# BID #709 – Ventura College STEM Program Building Improvements

## **ADDENDUM 001, dated 05/15/2025**

**DRAWING** changes and clarifications noted as Addendum 01 and dated 05/15/2025:

UTILITY PLAN  
SANITARY SEWER  
AND STORM DRAIN

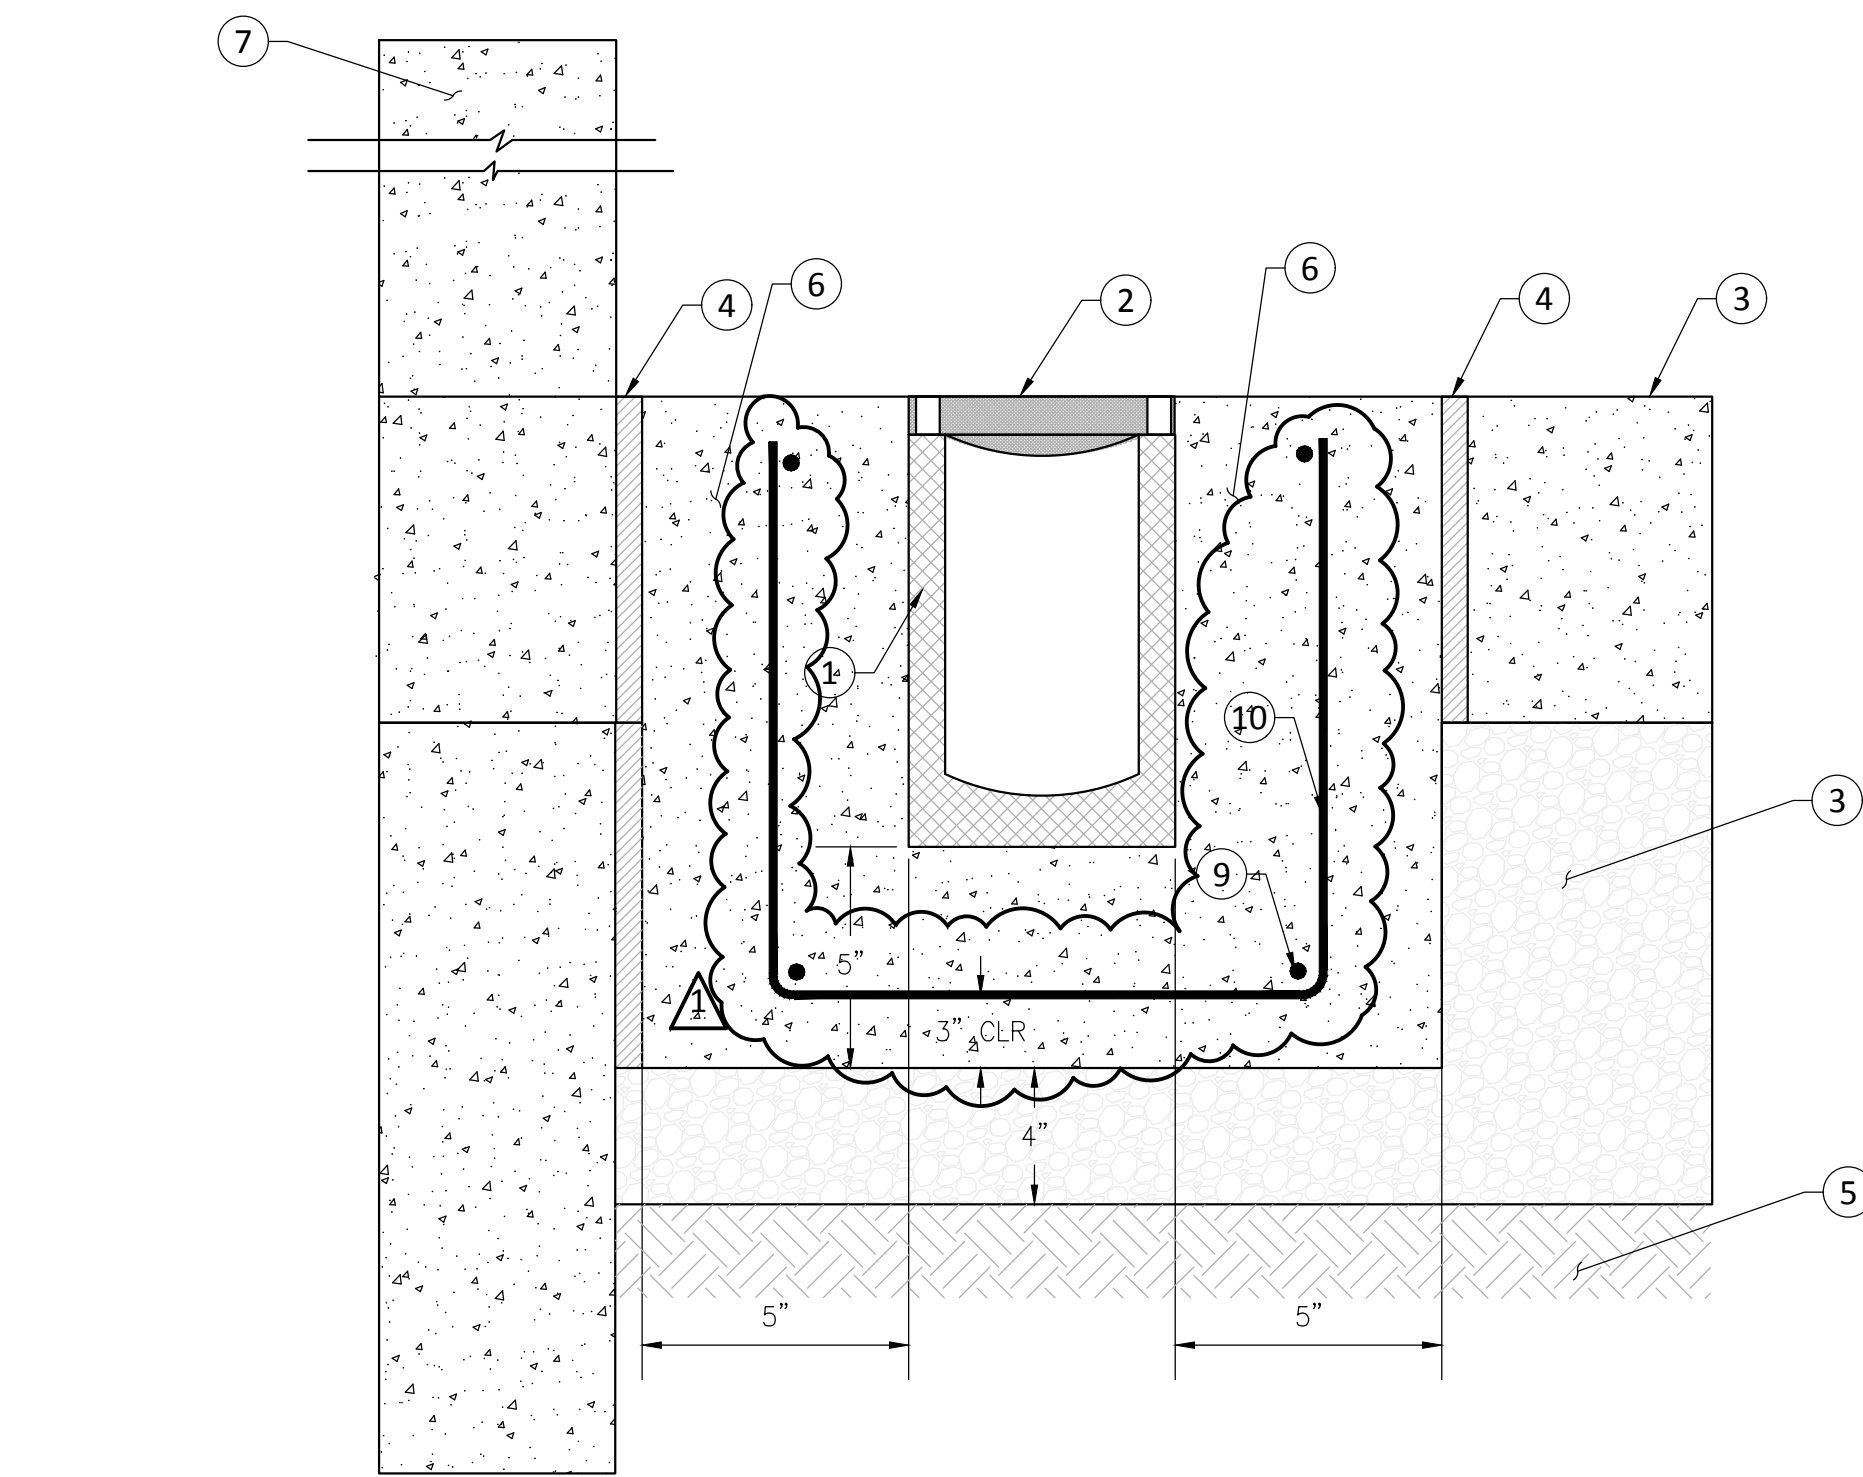
C4.0 – REALIGN NEW 6” DIAMETER SANITARY SEWER AND CLEANOUT, CONNECT TO EXISTING 6” DIAMETER SANITARY SEWER WITH CLEANOUT, REVISED SANITARY SEWER KEYNOTE 6, ADDED SANITARY SEWER POINT OF CONNECTION KEYNOTE 7, ADDED KEYNOTE 8, ADDED GENERAL NOTE FOR CONTRACTOR

TRENCH DRAIN

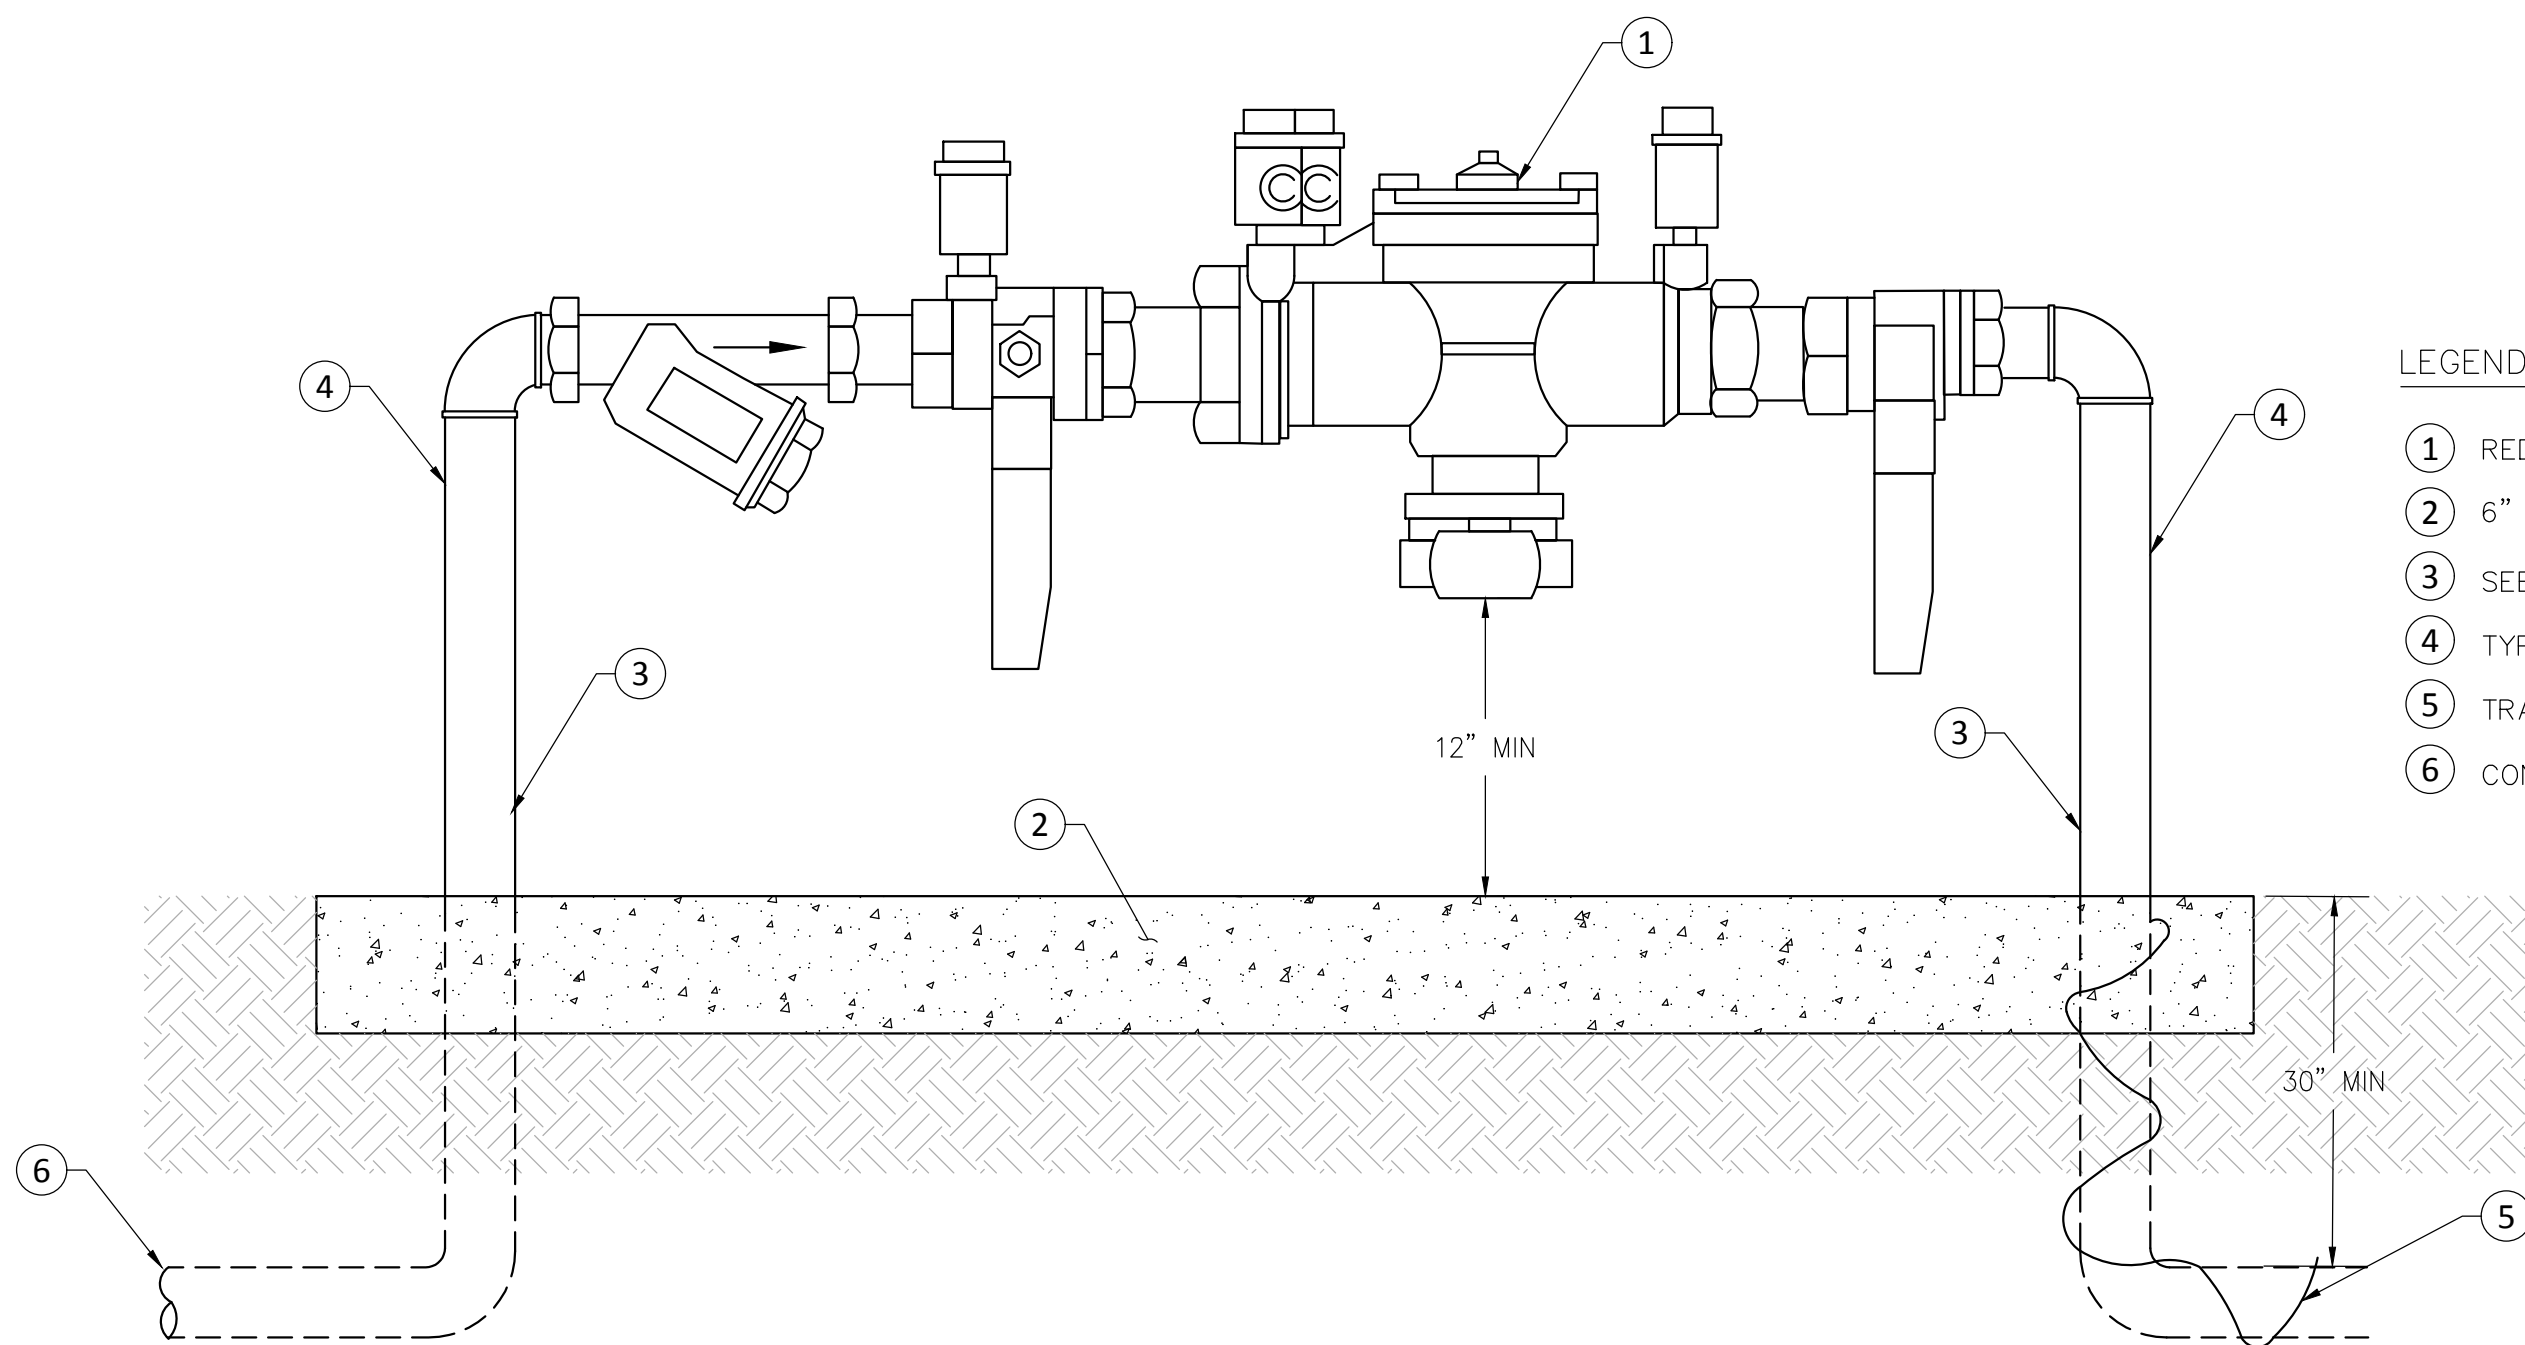
C5.1 – ADDED REINFORCEMENT TO TRENCH DRAIN DETAIL 12/C5.1, NEW CONCRETE V-GUTTER DETAIL 18/C5.1

# EROSION CONTROL PLAN

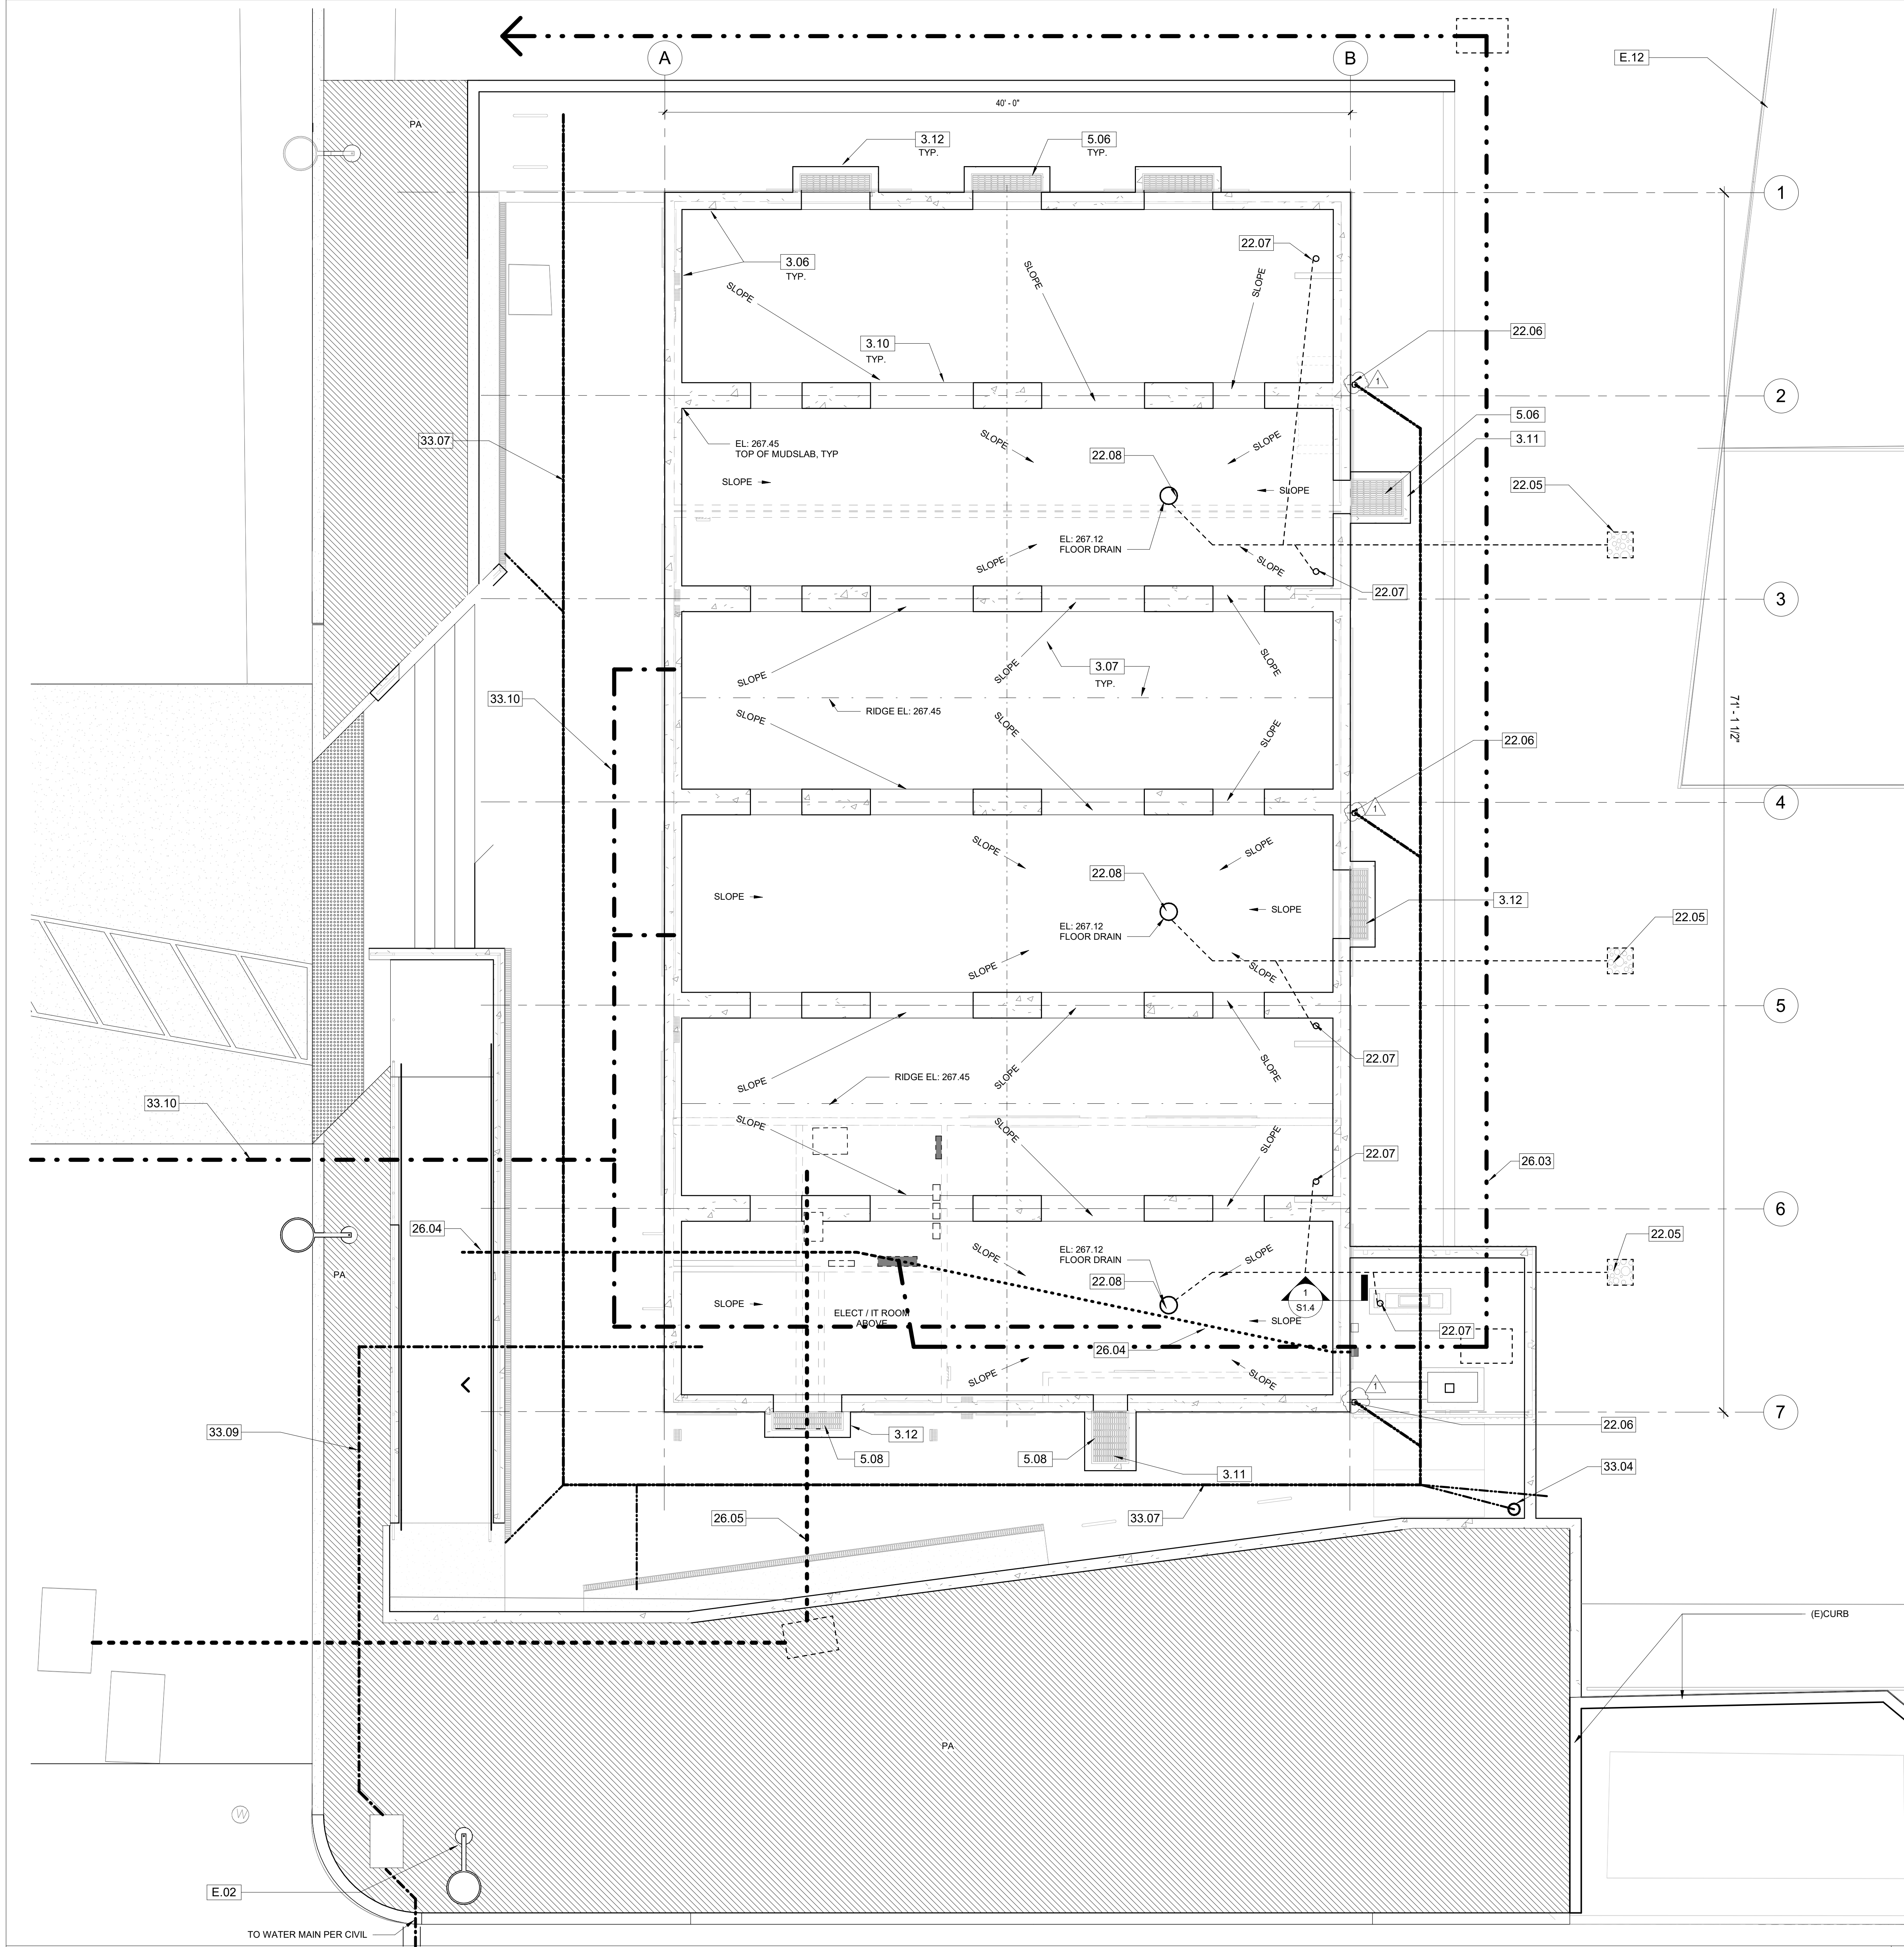
C6.1 – EROSION CONTROL PLAN FOR DROP-OFF AREA
